ADDENDUM NO. 2 - OUTLINE AND SUMMARY INFORMATION

Project Name: Molecular Bioscience Renovation & Maintenance PPA No.: 22-0045
Location: Montana State University Bozeman Campus Date: August 27, 2026

*The Plans and Specification prepared by (**Bechtle Architects**) dated (**Jun. 03, 2026**), shall be clarified and added as follow. The bidder proposes to perform all the following clarifications or changes. It is understood that the Base Bid shall include any modification of Work or Additional Work that may be required by reason of the following change or clarifications.*

1 Level 1 Electrical Plan
E111
1/8" = 1'-0"

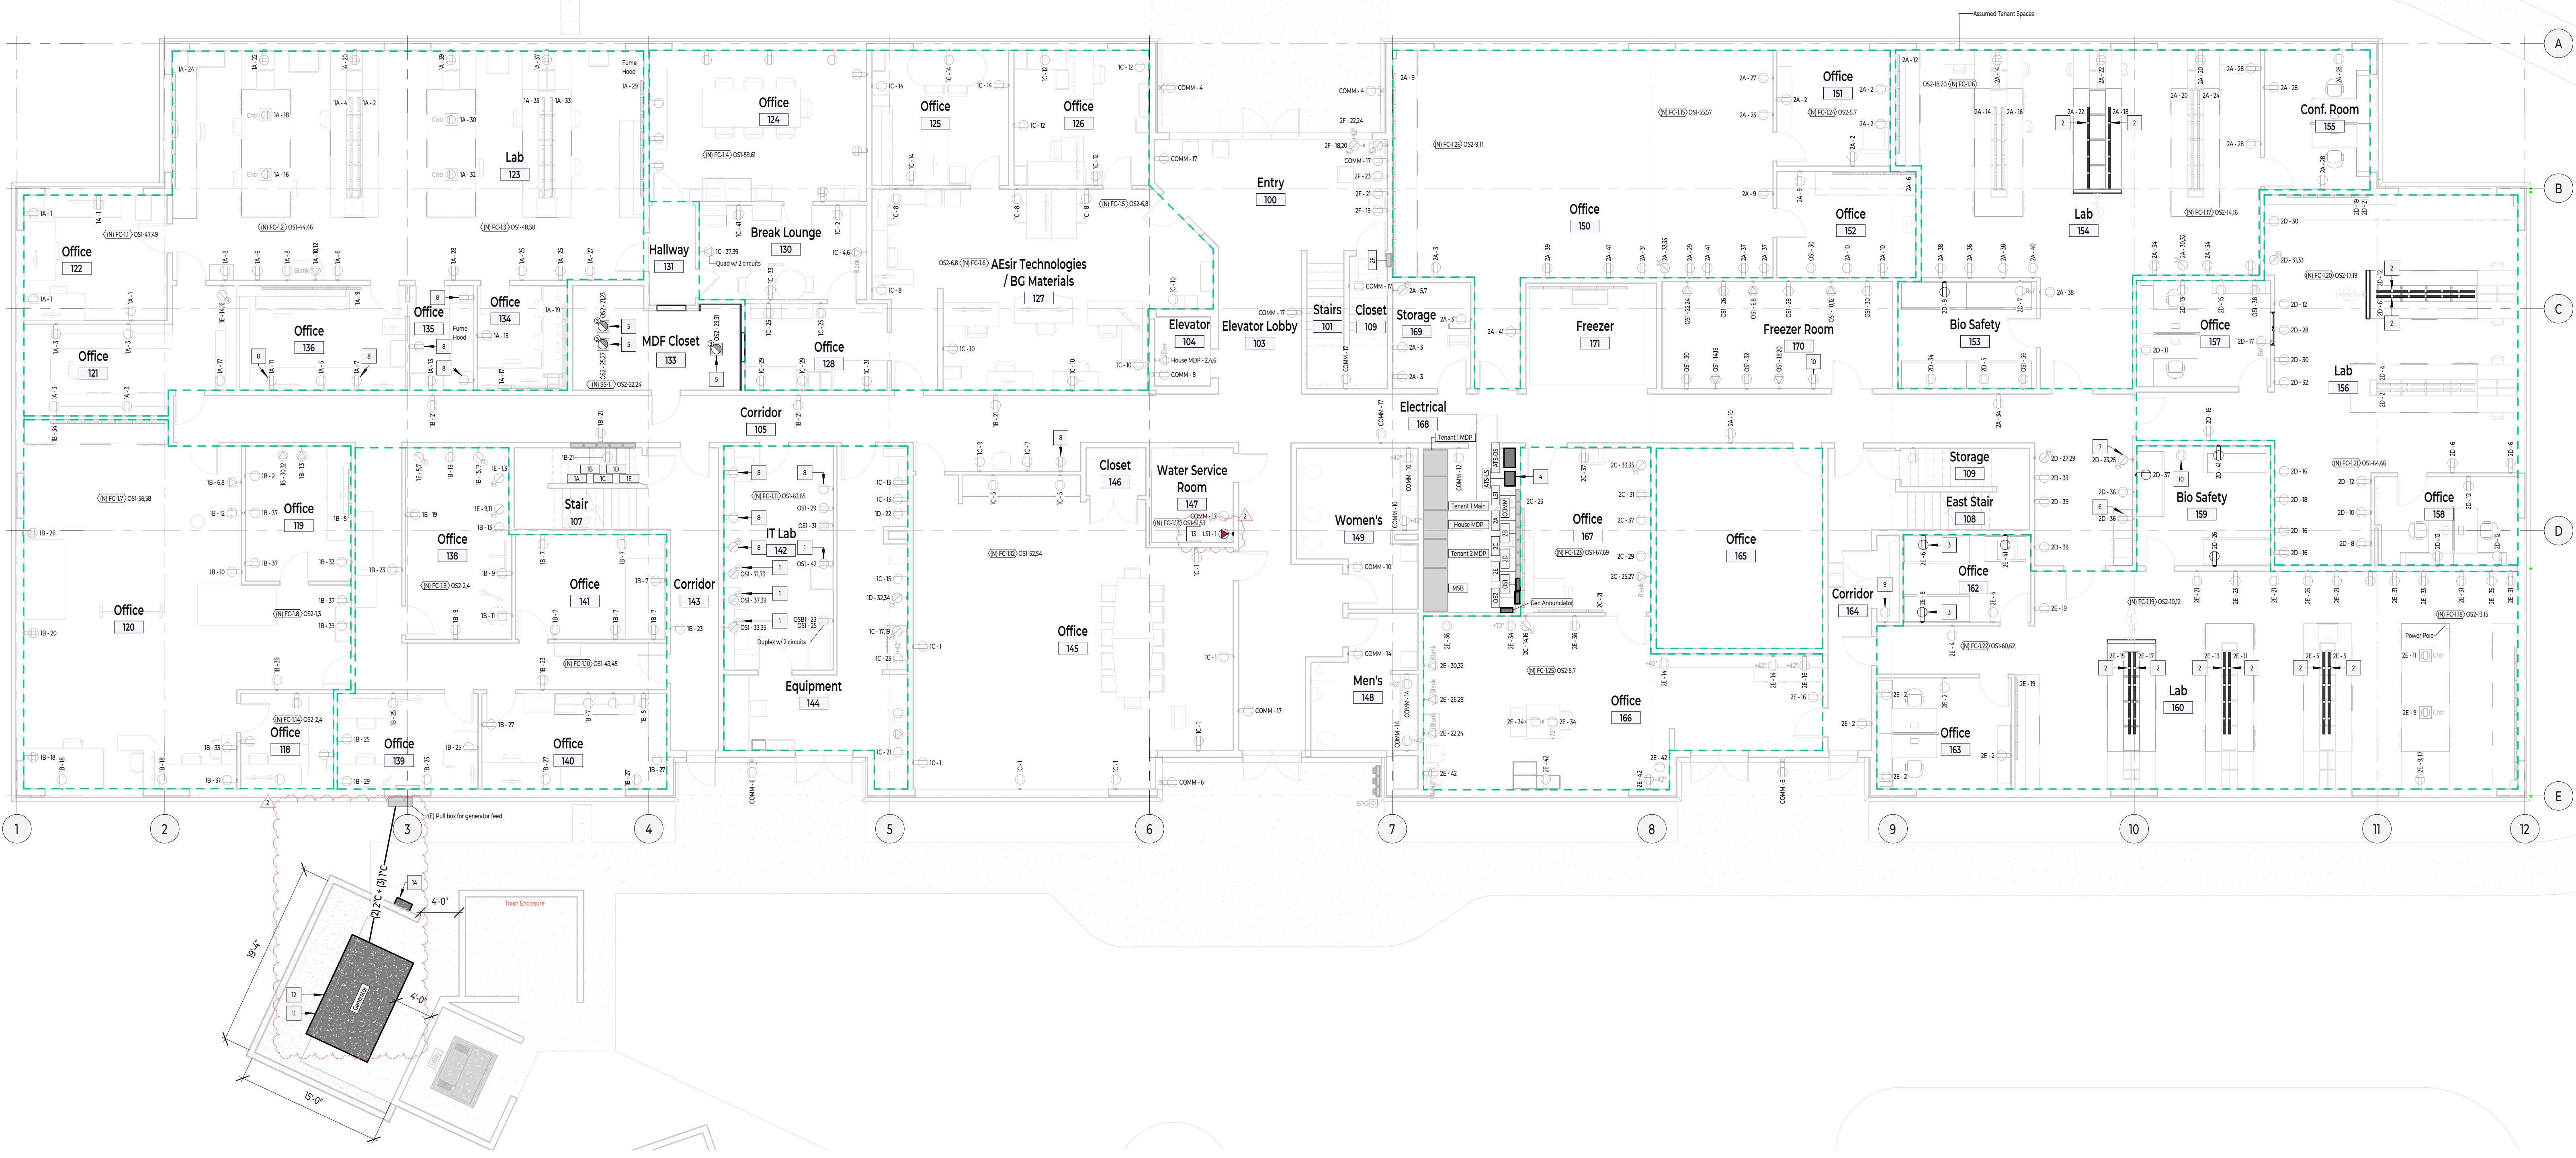
33) NOTE 7 ON E111 INDICATE THAT ITS UP TO THE EC TO VERIFY IF THE EXISTING POWER IS SUFFICIENT, PROVIDE AS BUILDS AND MFG NAMEPLATE DATA AND WE CAN OTHERWISE, SPECIFY CLEARLY WHAT EC SHOULD PROVIDE IF NOT SIZED APPROPRIATELY, OR REMOVE NOTE.

34) MULTIPLE NOTES ON SHEETS E111 AND E112 ARE SUPER VAGUE INDICATING THAT "CIRCUIT TRACING COULD NOT TRACING COULD NOT BE PERFORMED DUE TO THE EQUIPMENT BEING ACTIVE", "CIRCUIT TRACING COULD NOT BE PERFORMED, THIS RECEPTACLE WAS NOT ACCESSIBLE", "CIRCUIT TRACING COULD NOT BE PERFORMED. CIRCUIT NUMBER ASSUMED FROM EXISTING PANEL SCHEDULE", "THIS JUNCTION BOX CAPPED OFF WITHIN PANEL 3B", "JUNCTION BOX HAS BEEN BLANKED OFF, NO CIRCUIT TRACING WAS MARKED", "JUNCTION BOX DOES NOT HAVE CIRCUIT, BOX WAS EMPTY", "EC SHALL REPLACE EXISTING DEAD OUTLET WITH NEW. VERIFY OUTLET IS FUNCTIONAL OR REPLACE BRANCH CIRCUIT BACK TO PANEL" THAT PROVIDE VERY LITTLE CONTEXT AS TO WHAT THE EC SHOULD BE CARRYING IN THEIR PROPOSAL PUTTING THE EC AND/OR OWNER AT RISK OF NOT CAPTURING THIS COST OR CAPTURING COST THAT

a) Blacksheep Response: EC shall provide to Engineer what is currently installed. Engineer will verify if power is sufficient. Note reworded as part of Revision 1

E.C. shall inform Engineer of what size wire is connected to device. Engineer shall verify existing circuit is sufficient for new cooler. Circuit was labeled as (2) circuit plugload on panel schedule. This is a 30A2P breaker. Assuming this is 2P10 CU.

E.C. shall replace existing dead outlet with new. Verify outlet is functional or replace branch circuit back to panel.

1 Level 2 Electrical Plan
ET12 1/8" = 1'-0"

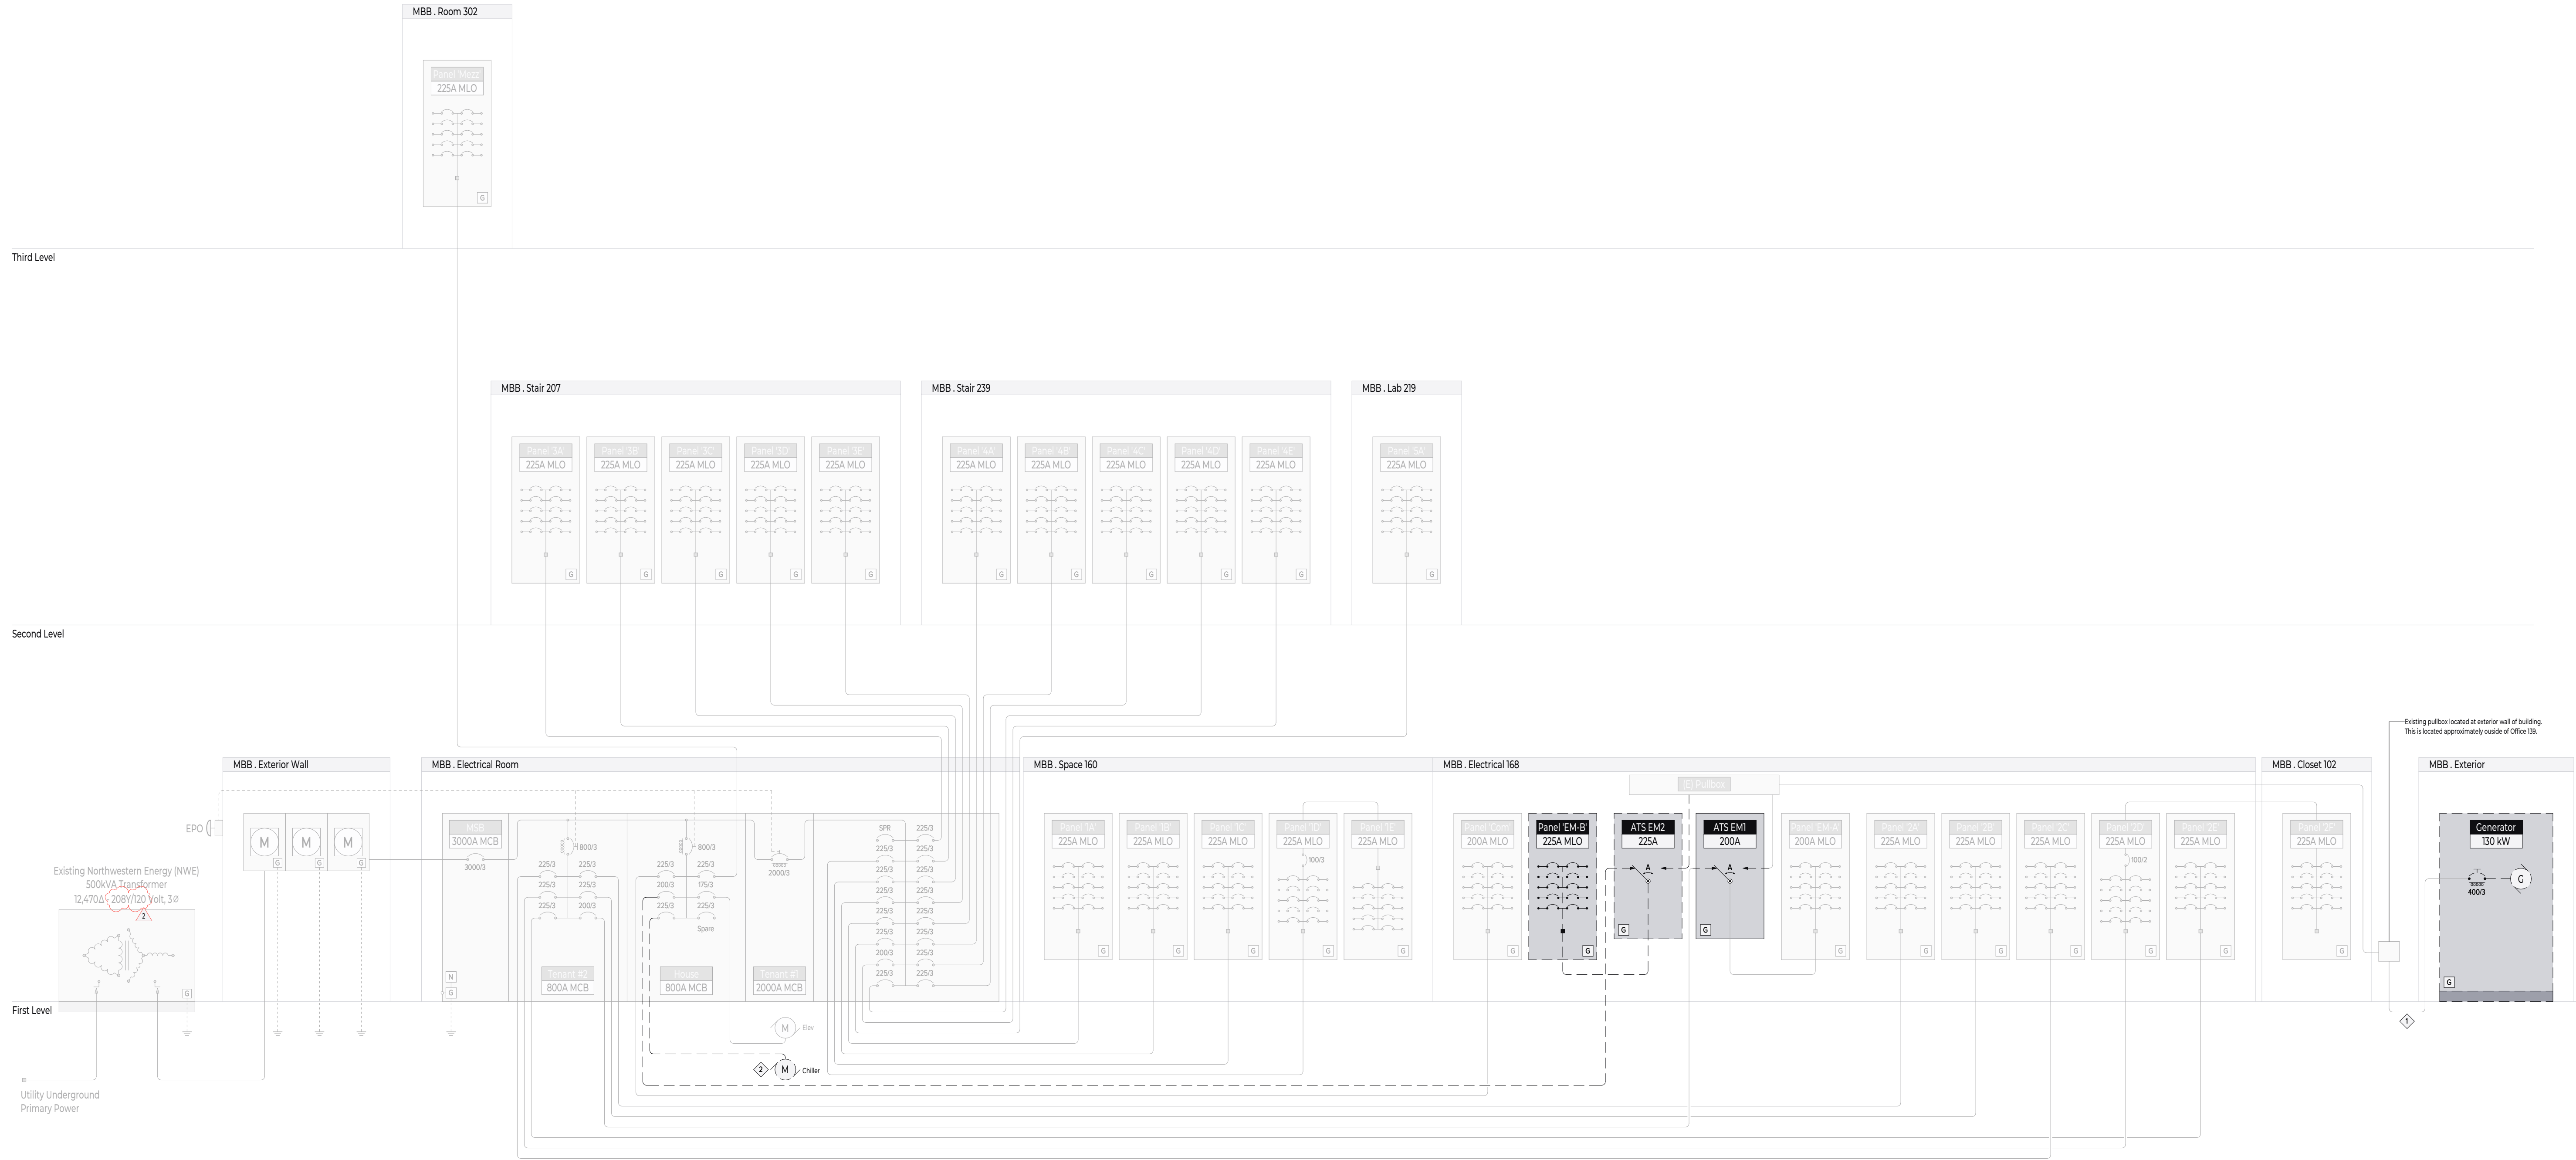
30) SHEET E112 NOTE 4 INDICATES THAT THE OUTLETS ARE INTEGRAL TO BIO SAFETY CABINET WITH NO OTHER DIRECTION, CONFIRM IF SOMETHING IS NEEDED HERE.

31) SHEET E112 NOTE 7 INDICATES TO VERIFY IF CIRCUIT IS DEDICATE OR NOT, PROVIDE DIRECTION ON HOW CONTRACTOR SHOULD PRICE FOR NOW SINCE WE DON'T KNOW IF ITS DEDICATED OR NOT AT THIS TIME.

32) PANEL SCHEDULE NOTES CIRCUITS 22, 24, 26 AS NEW RECEPTACLES YET NOTHING IS NOTED ON SHEET E112 FOR WHAT WE NEED TO DO, PROVIDE DIRECTION FOR THESE DEVICES.

a) Blacksheep Response: This was a note for as built. All receptacles on this sheet with that note are existing.

a) Blacksheep Response: EC should plan on adding in pricing for replacing branch circuit from panel to be safe

a) Blacksheep Response: Verified with Third Element that this is about panel 4E. These devices are new to this room (Office 221). Provide receptacle + branch circuit from panel.

| 1. E.C. shall replace existing dead outlet with new. Verify outlet is functional or replace branch circuit back to panel. | 1. Installation of all work shall be in accordance with all local codes and ordinances and the edition of the National Electric Code NFPA 70 (NEC) in effect. |
| 7. Verify outlet is dedicated for new Bio Safety cabinet. | |
